Subject: **WATER AND WASTEWATER CAPACITY AVAILABILITY LETTER**
633 SE 3rd Avenue – DRC Case No. UDP-S22042
633 SE 3rd Avenue, Fort Lauderdale, FL 33301

City of Fort Lauderdale
Public Works Department
Water and Wastewater Capacity Analysis

633 SE 3rd Avenue – DRC Case No. UDP-S22042
633 SE 3rd Avenue, Fort Lauderdale, FL 33301

Figure 2 – City Sewer Atlas

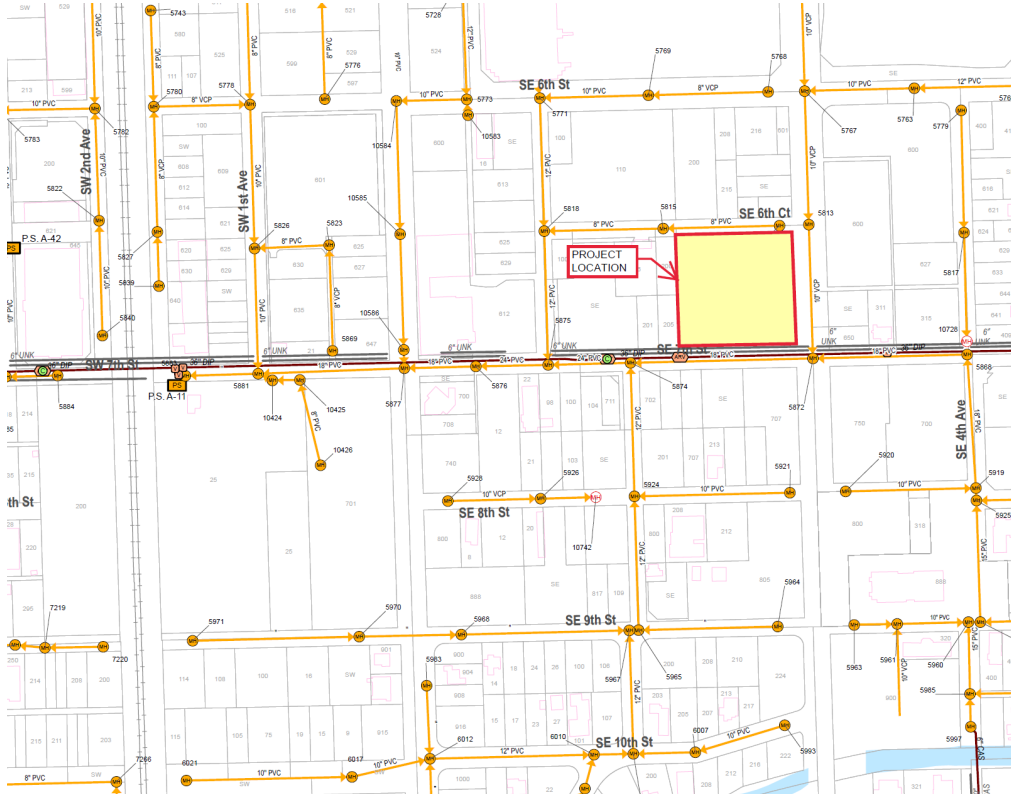
Wastewater: The site is currently served by an 8-inch gravity sewer main along SE 6th Court to the north of the project site and by an 18-inch gravity sewer on SE 7th Street to the south of the project site. See Figure 2.

Evaluation of impact on existing collection pipe: According to the site plan, the applicant is proposing to utilize the 8-inch gravity sewer main along SE 6th Court to the north of the project site and the 18-inch gravity sewer on SE 7th Street to the south of the project site. The City uses a peak hourly flow factor of 3.0. Accounting for existing flows and based on the tools and information available to the City staff, it has been calculated that the pipes downstream of the proposed development will flow greater than the City's governance plan threshold of 70% during peak flows. Therefore, the pipes downstream of the developments do not have adequate capacity to serve the project and will have to be upsized prior to issuing the Certificate of Occupancy for the proposed development.

Figure 3

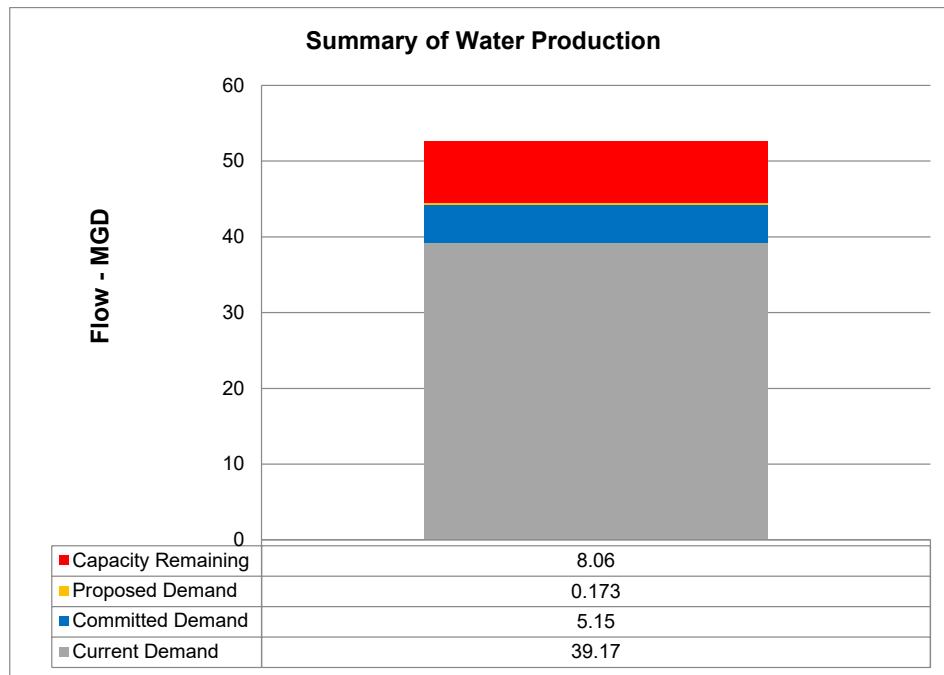
Evaluation of impact of Permitted Water Plant Capacity: The Fiveash and the Peele Dixie Water Treatment Plants are designed to treat 70 MGD and 12 MGD of raw water respectively (82 MGD total). The total permitted Biscayne aquifer water withdrawals for these plants is limited to 52.55 MGD per the South Florida Water Management District (SFWMD) permit number 06-00123-W.

The current twelve-month rolling average production at the two plants is 39.17 MGD. The previously committed demand from development projects in the permitting or the construction stage is 5.15 MGD. Combining these figures with the demand from the proposed project of 0.1730 MGD, the required production would be 44.49 MGD. This is less than the allowable withdrawal limit of 52.55 MGD. Therefore, the water plants have sufficient capacity to serve this project. See Figure 3 below.

Figure 5

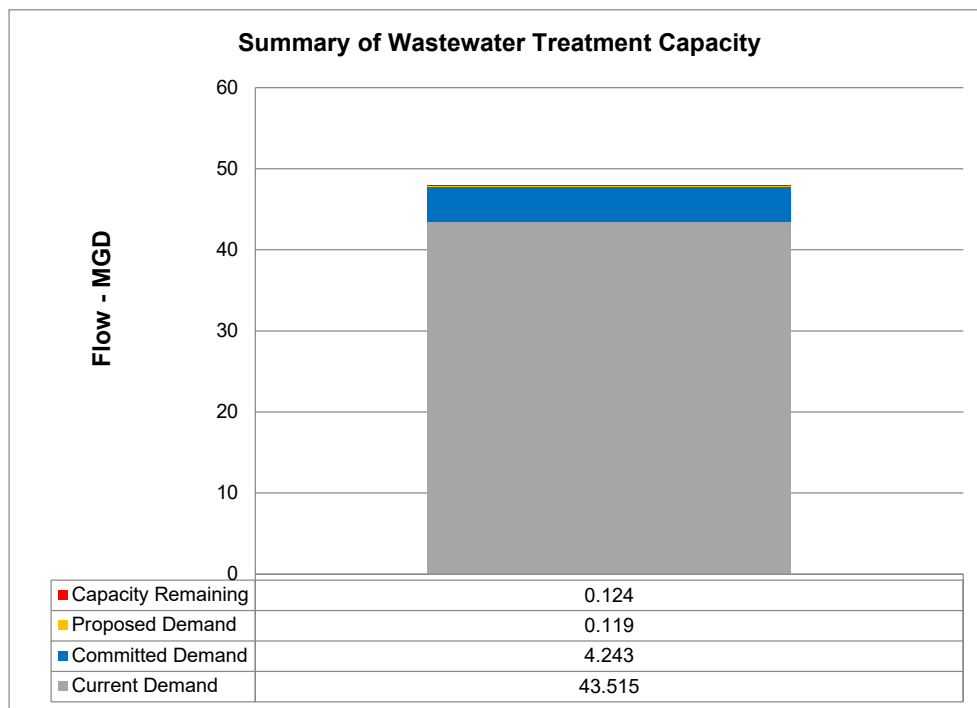
Evaluation of impact of Permitted Wastewater Plant Capacity: The City of Fort Lauderdale owns and operates the George T. Lohmeyer Regional Wastewater Treatment Plant (GTL), which provides wastewater treatment for the City of Fort Lauderdale. The Broward County's Environmental Protection and Growth Management Department's (EPGMD) Environmental Licensing & Building Permitting Division's licensed capacity for GTL is 48 MGD-AADF (Million Gallons per Day – Annual Average Daily Flow). The annual average daily flow (AADF) to the plant is 43.51 MGD. Combining the committed flows for previously approved projects of 4.24 MGD plus the 0.1191 MGD net contribution from the project results in a total projected flow of 47.88 MGD. This is less than the permitted treatment plant capacity of 48 MGD. Therefore, the treatment plant has sufficient capacity to serve this project. See Figure 5 below.

Figure 6

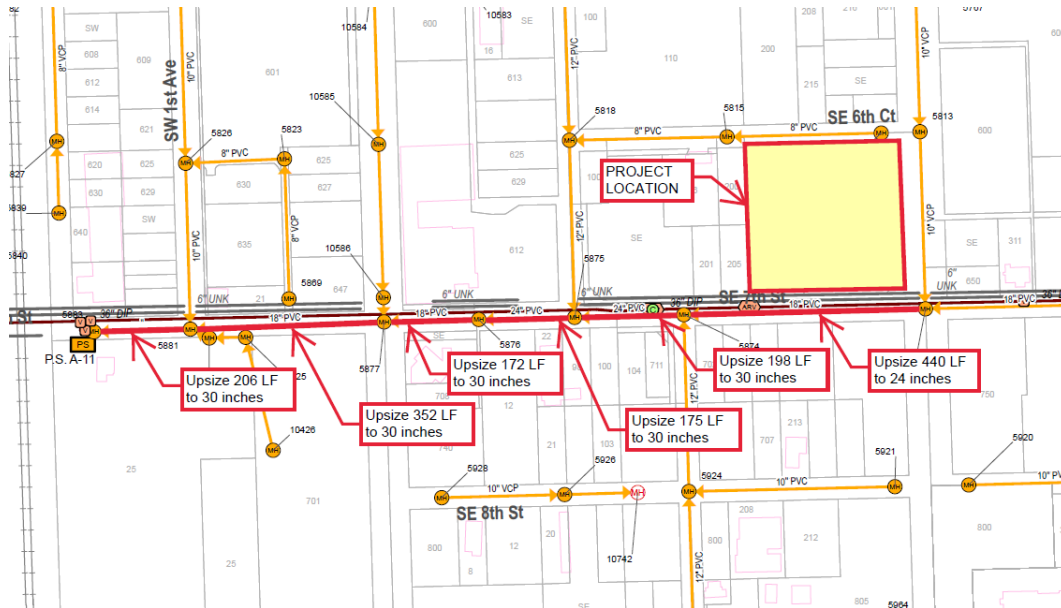
Recommended Wastewater Infrastructure Improvements: The existing sewer infrastructure does not have the capacity to support the proposed development and the following improvements will be required to accommodate the proposed flow increase before the Certificate of Occupancy is issued:

- Approximately 440 LF of 18-inch gravity line along SE 7th Street will have to be upsized to 24 inches (see Figure 6).
- Approximately 1,103 LF of 18-inch and 24-inch gravity lines along SE 7th Street will have to be upsized to 30 inches (see Figure 6).
- PS A-11 projected NAPOT will increase to 16.87 hours, therefore the PS A-11 will have to be upgraded to be able to handle the flow increase from the project.
